RE: **Addendum No. 2/City of Mission Event Center**
Request for Proposal No.: 17-010-11-29

ADDENDUM 2

.....
Date: 11-22-2016
Project: Mission Event Center
Project No.: 2016-01
.....

ZDA ARCHITECTURE 2802 N. Flores San Antonio, TX 78212 210.334.7371 zda@zda-architecture.com	ADDENDUM NO. 2 MISSION EVENT CENTER 210 N. SHART RD. MISSION, TX. 78572		SHEET NO. A-1 1 of 6
	DATE 11-22-2016	PROJECT NO. 2016-01

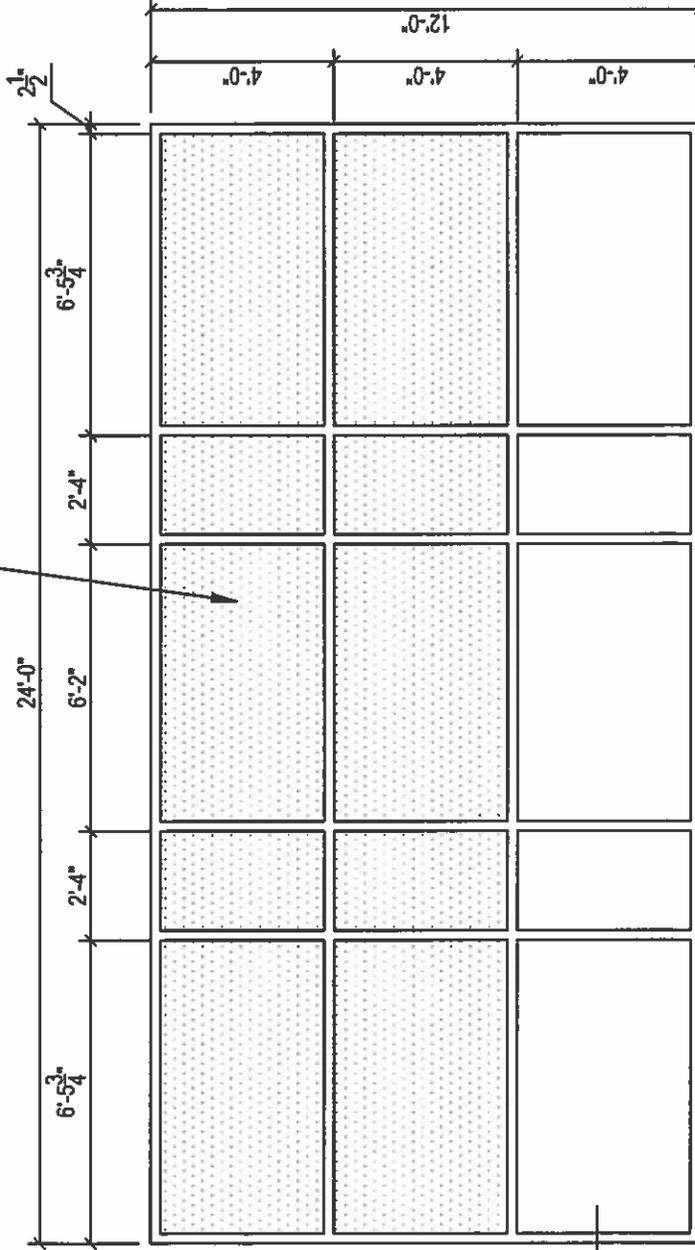
1. **Correction:** Bid Proposal Due Date and Time: **Friday, December 2, 2016 AT 2:00 P.M. (CST).** Refer to revised Bid Form attached herewith.
2. **Modification:** Low-voltage motorized shades will be added to the four (4) Curtain Walls, (Type CW5) along Corridor 121 & Corridor 101 on the west side of the building. Refer to revised **Sheet A-1 & A-2** attached herewith.

SHEET NO.
A-2
 2 of 6

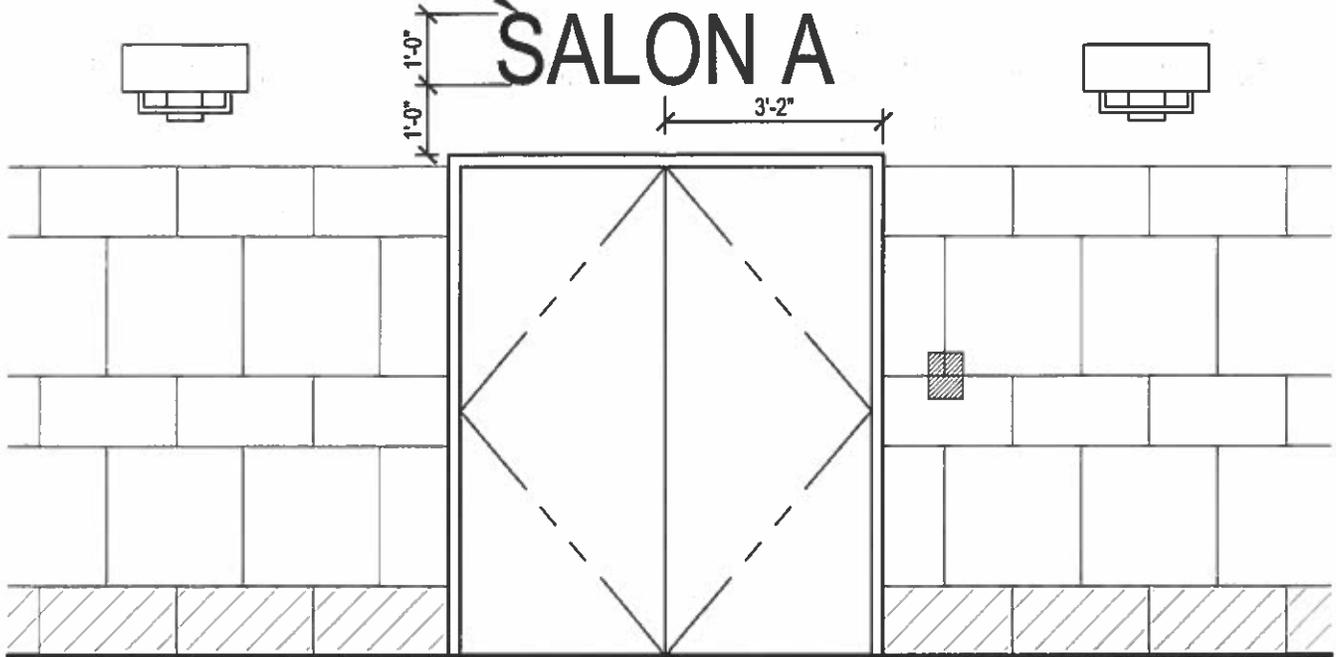
LOW-VOLTAGE MOTORIZED SHADE WILL
 ONLY COVER UPPER PART OF WINDOW
 CONTACT: TERRI CLARK
 BELL & McCOY PH: 210-832-9205, PH: 210-941-9967
 E-MAIL: TCLARK@BELLANDMCCOY.COM

A-3

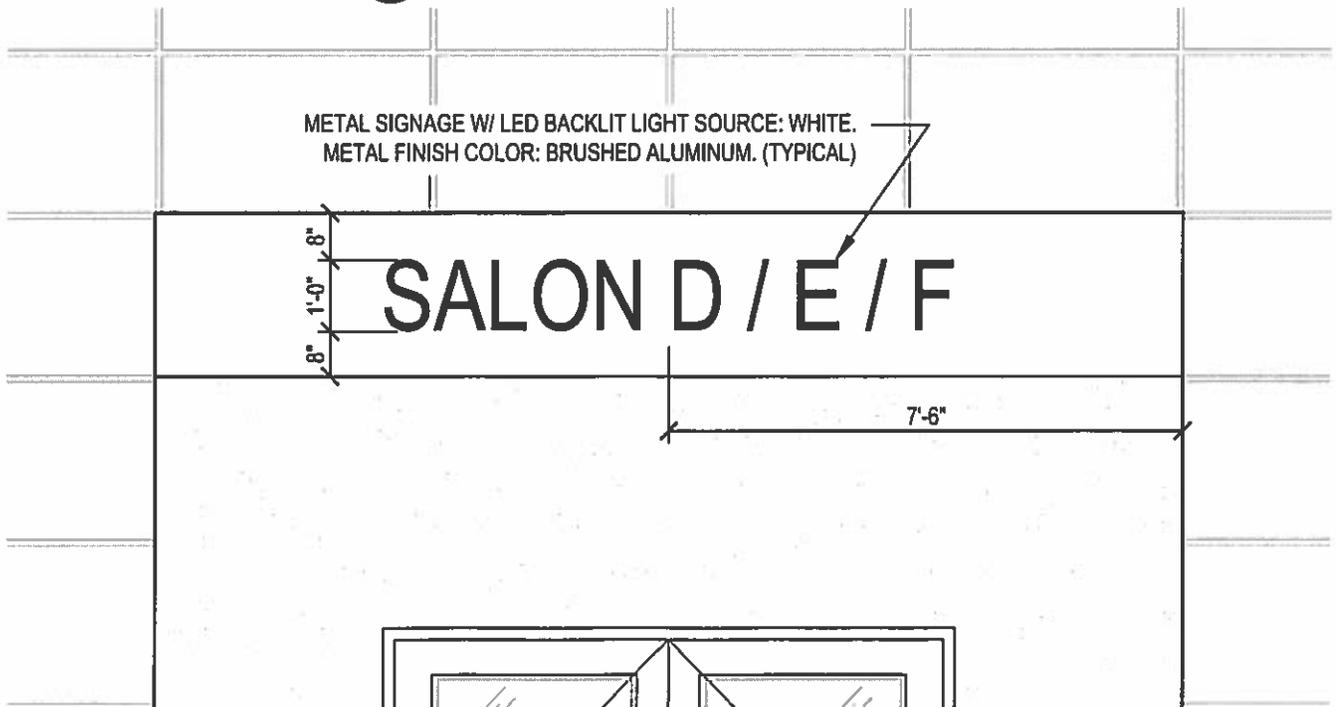
3. **Clarification:** Updated contact information for Terri Clark (Bell & McCoy)
Ph: 210-832-9205, Ph: 210-941-9967, Email: TClark@bellandmccoy.com
4. **Clarification:** Signage sizes and locations have been clarified. Refer to revised **Sheets A-3, A-4, A-5 & A-6.**

METAL SIGNAGE W/ LED BACKLIT LIGHT SOURCE: WHITE.
 METAL FINISH COLOR: BRUSHED ALUMINUM. (TYPICAL)

METAL SIGNAGE W/ LED BACKLIT LIGHT SOURCE: WHITE.
 METAL FINISH COLOR: BRUSHED ALUMINUM. (TYPICAL)
